SECTION 00 91 13 – ADDENDA (ADDENDUM #2 – ISSUED 08/24/23)

- A. Project Name: RVCC Lab Renovations
- B. Owner: Community College System of New Hampshire
- C. Architect: Warrenstreet Architects, Inc.
- D. Architect Project Number: 3773
- E. Date of Addendum: **August 24, 2023.**

CURB CAP DETAIL

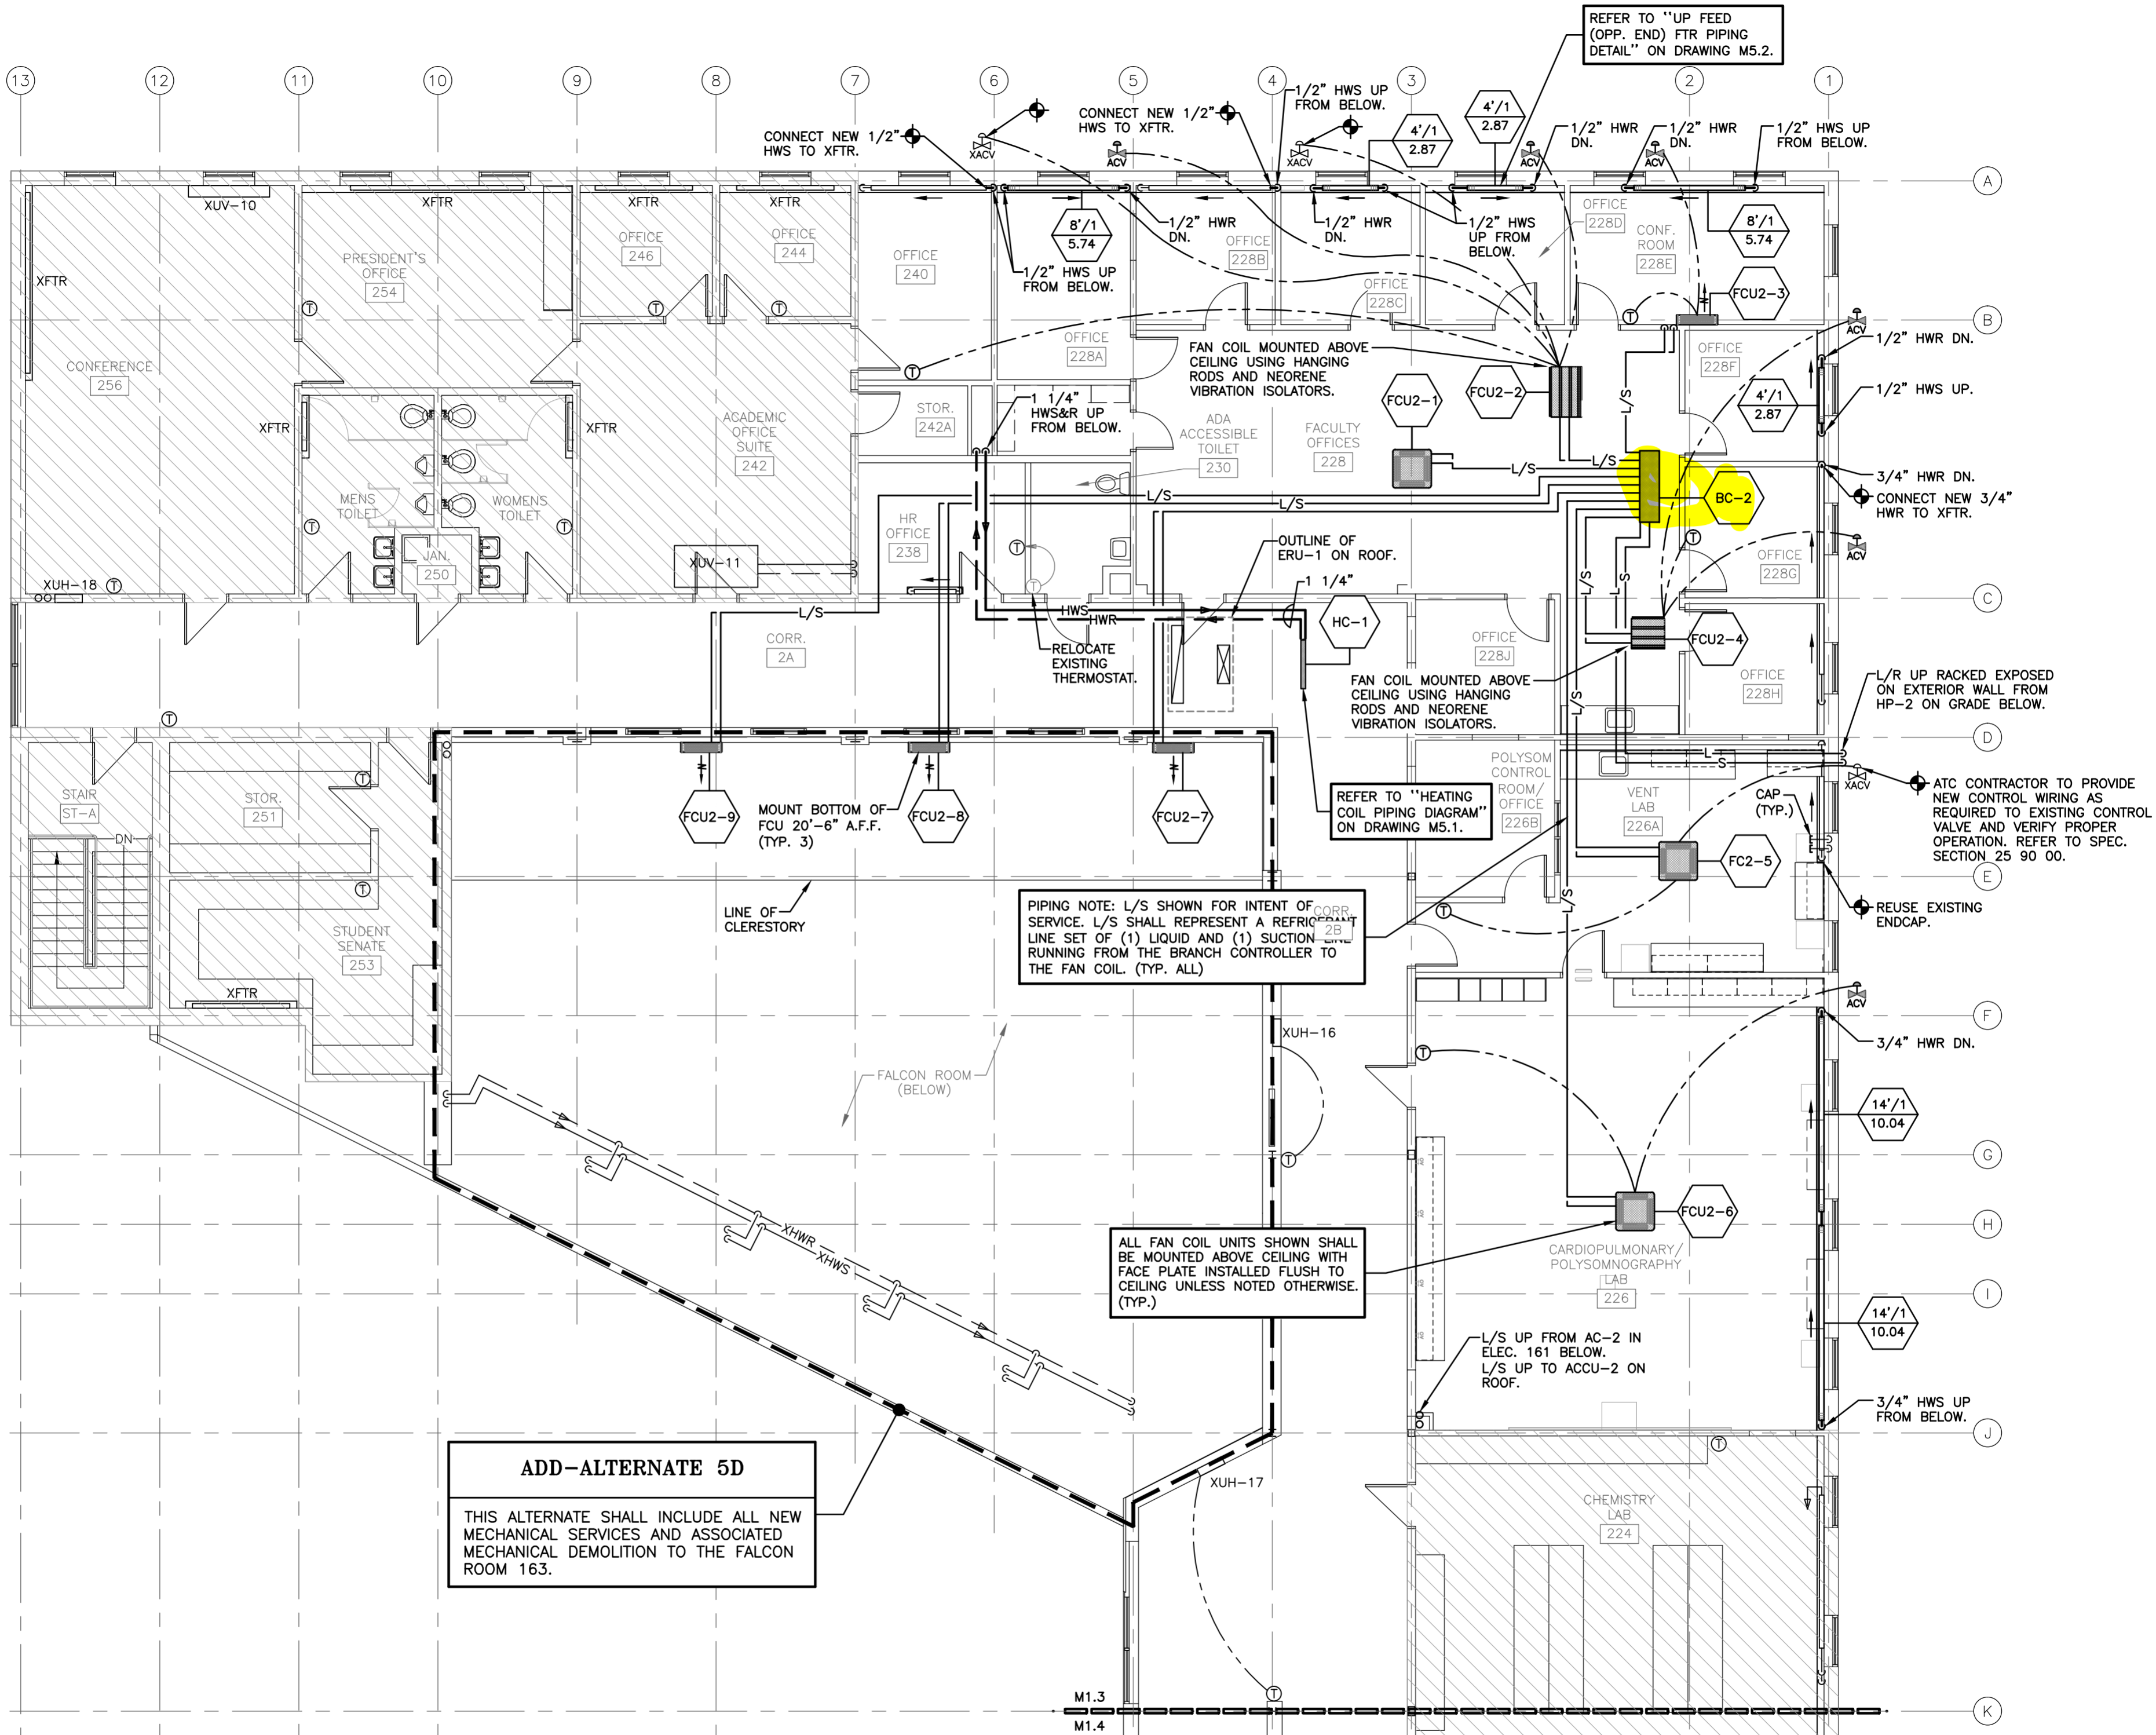
1. RESPONSE: Panels are to be 8' in length.
- D. QUESTION: Demo Note # 4 on M1.2 says to insulate, cap and make watertight the roof curbs for the exhaust hoods. Please provide a detail for this work.

1. RESPONSE: See attached detail.
- E. QUESTION: Note 5 on M1.2 says to connect new liquid & suction piping from Fc-1 to XBC-2. How far away is XBC-2?
1. RESPONSE: See attached for anticipated location. Approximate distance is 100', final length may vary with run of piping.

WATERTIGHT, COUNTER
FLASHED SHEET METAL CAP.
FIELD VERIFY EXACT SIZE.

CAP SIDES TO EXTEND
MIN. 4" DOWN EXISTING
CURB. PROVIDE 1/4"
HEMMED OUT DRIP EDGE.
